Service-Information

Cust.Serv.-Techn.Dept. VKT er-lü/wi/fm	2-Cylinder Motorcycles Group: Engine	Munich, 18 June 1964 Nr. 3/64 (211) en.
---	---	--

Re: Disc Springs for Clutch with increased Application-Pressure

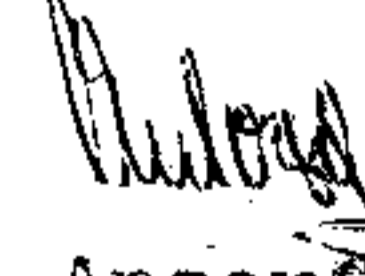
Please note that we have introduced reinforced clutch disc springs in order to avoid an occasional slipping of the clutch on the models R 69 S and R 60.

springs marked with a red plus-sign - Part Nr. 00 70 182 - (Application Pressure 366-397 lbs.) are installed as standard equipment.

springs marked with a red minus-sign - Part Nr. 00 70 183 - (Application Pressure 330-364 lbs.) will be used.

The disc springs have undergone modification only as far as the material is concerned, no change was made in the dimension and clearances.
